Service Bulletin

**Revised version:
Additional installation steps for VDI 3.1 added**

Release of NX 3.0.8950, XRDI 18.0, ASC 4.1 and VDI 3.1

DX-D 100 / DX-D 100 Wireless

Figure 1

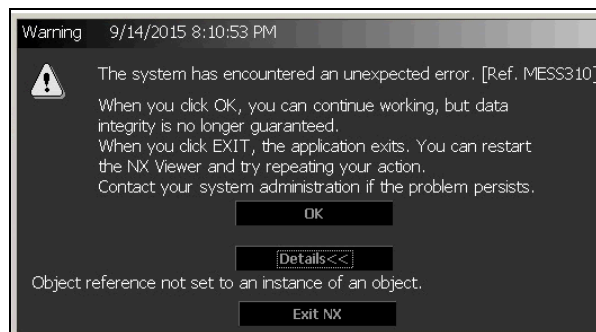
1.2.3 MESS310 at systems with touch screen when leaving Viewing and Editing screen [PRB0049311]

Symptom Error MESS310 when leaving the Viewing and Editing screen. The following preconditions must be fulfilled so that the symptom appears:

- System has NX 2.0.8900 / 3.0.8900 (SU1 / SU2) installed and is configured for touch mode (for DX-D 100 touch mode is always activated).
- Collimation Tool is deactivated (activated by default).

Cause Software bug introduced in NX 2.0.8900 / 3.0.8900 as part of the introduction of Touch Mode buttons in the Viewing and Editing environment: When leaving the Viewing and Editing environment, the software wants to close the Collimation Tool combo box. If this is not available MESS310 is shown.

Solution In NX 3.0.8950 the issue is solved.

Figure 2

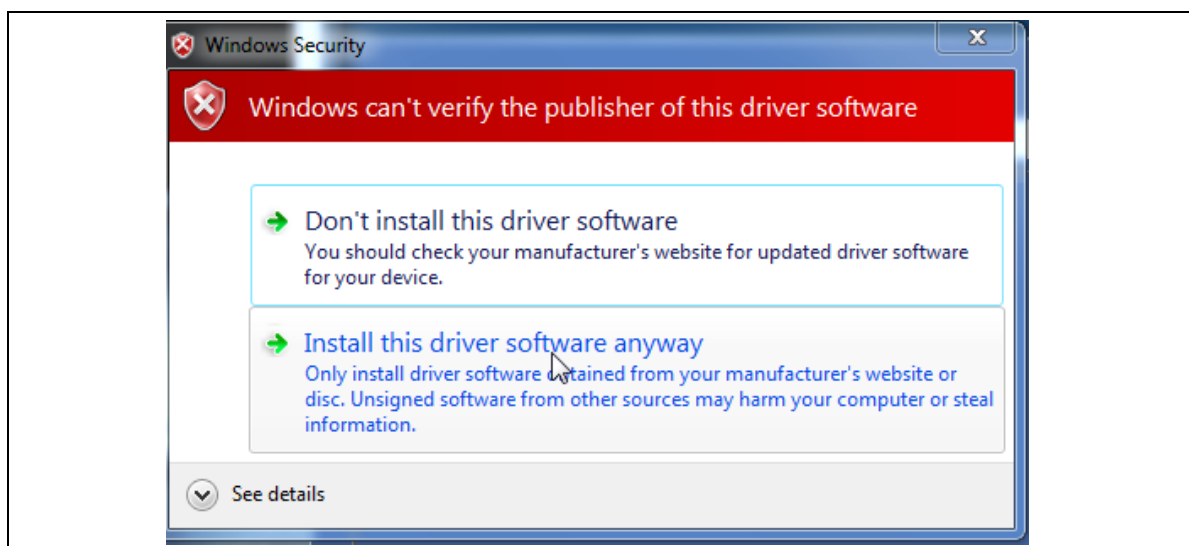
Note that the following error may occur during installation!

Symptom During installation, Windows security triggers a pop-up message

Cause

Solution Workaround solution: Select “Install this driver software anyway”.

Figure 4

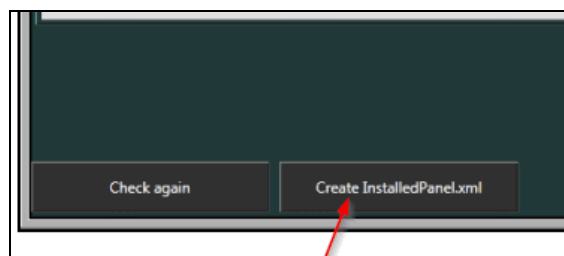
After the installation of VDI 3.1 it is required to perform the following steps:

- Make sure that the detectors are green selected in Vivix Setup.
- Open the VDI Panel Installation tool.
- Click the 'Create InstalledPanel.xml' button.
